# CITY OF ALBUQUERQUE

RE: **McDonalds – Coors and Hanover**  
**1501 Coors Blvd NW**  
**Grading Plan**  
**(Non-stamped) Plan Date: 1/16/17 (File: J11D037)**

Based upon the information provided in your submittal received 1/30/2017, the Grading Plan is not approved for Building Permit. The following comments need to be addressed for approval of the above referenced project:

| GRADING<br>PLAN<br><b>C7.0</b> |  |

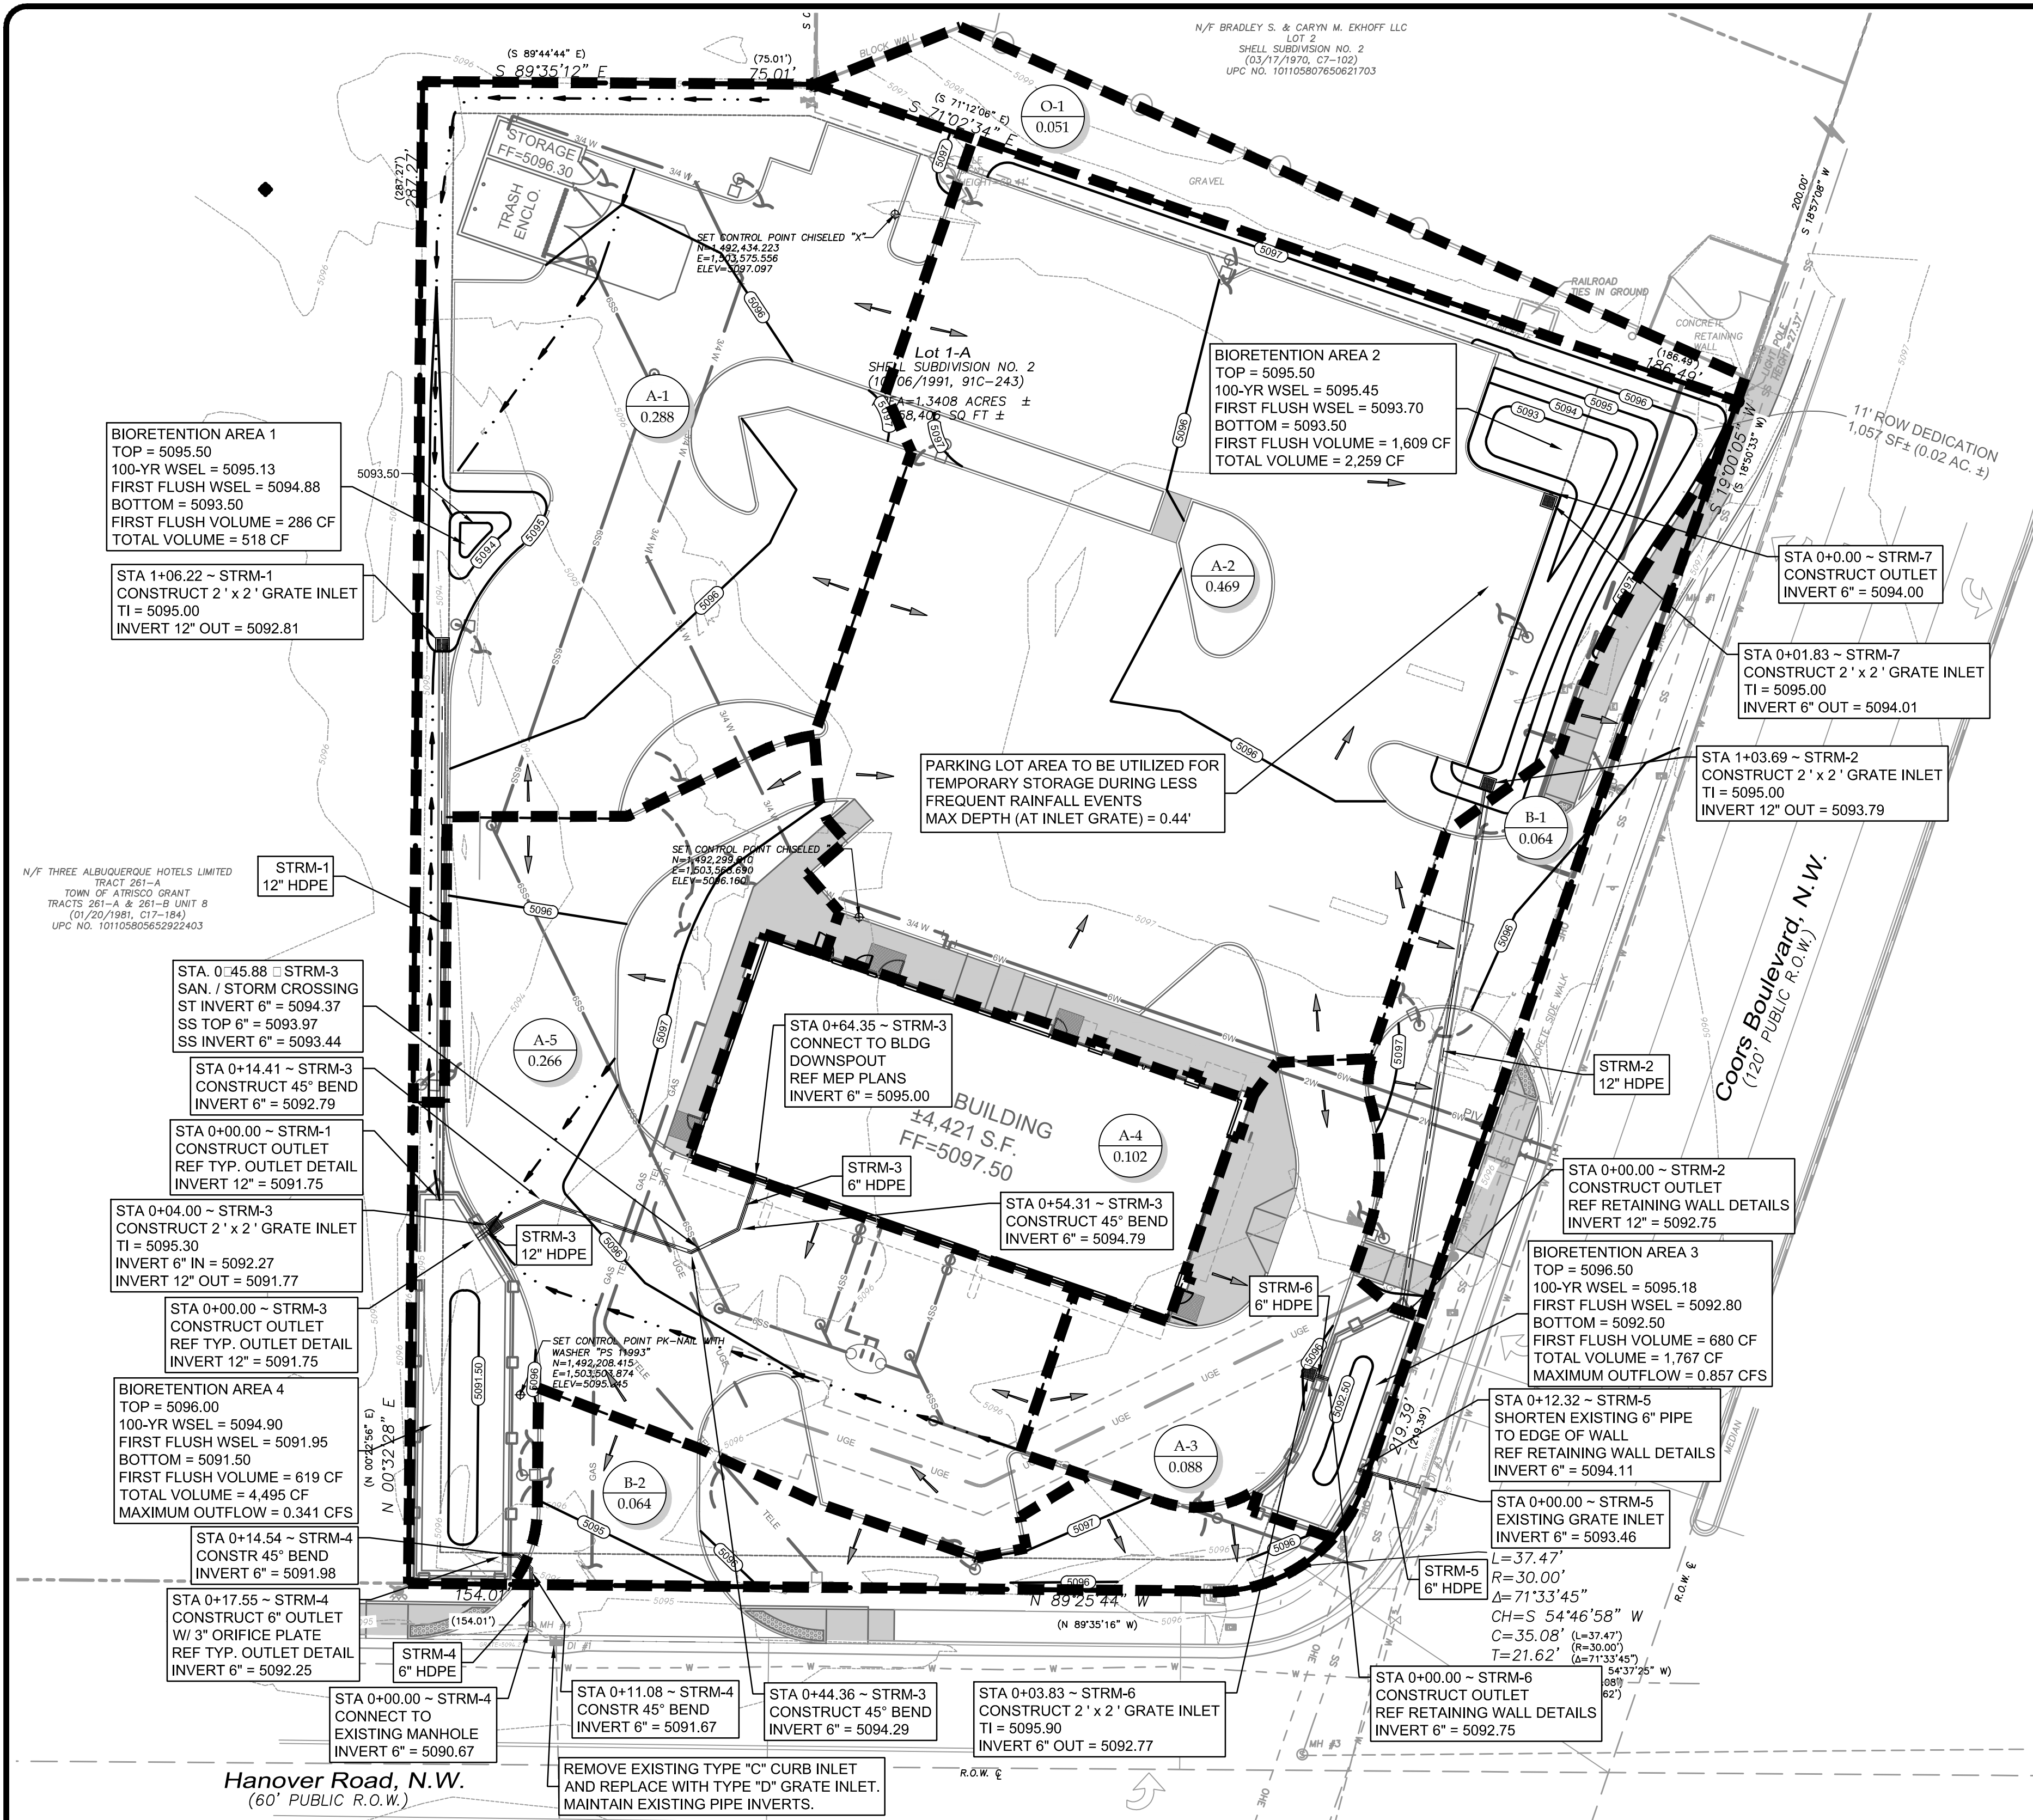
1. Conversion of DI#1 from a Type Single C to a Type Single D requires one of the following as there is no throated inlet less than 150' upstream of this catchment:

- a. A throated drop inlet (Type A or C) may be added within 150' upstream of DI#1.
  - b. DI#1 may be replaced with a Type Double-D inlet. This seems to be the more feasible option.

2. For connections to City Facilities, storm drain material must be RCP Class 3 or 4, PVC, Ductile Iron Pipe, or HPPP (High Performance Polypropylene Pipe). This applies to STRM-4 tying into MH#4. Additionally it may be more feasible to tie directly into the back of DI#1.

3. Will adjustments be needed to raise or lower MH#4 on Hanover? This is currently on the sidewalk and is proposed to be in the drivepad.
4. Ensure the fence around Bio-retention Areas 3 and 4 is at least 42" in height.

5. Waterblocks, at least 8" high from top of pavement on the drivepad to bottom of gutter along the road, need to be incorporated at the Coors entrance.

6. Please coordinate with NMDOT for work within their ROW along Coors Blvd. Provide correspondence showing coordination.
7. This work will require an Erosion and Sediment Control Plan submitted to the storm water quality engineer (Curtis Cherne, PE, [ccherne@cabq.gov](mailto:ccherne@cabq.gov)) before Building Permit Approval.
8. The Grading Plan will need to be sealed by the Engineer prior to approval by Hydrology.

Modifications to existing inlet DI#1 and MH#4 will require an SO-19 Permit. If you have any questions, please contact me at 924-3695 or [dpeterson@cabq.gov](mailto:dpeterson@cabq.gov).
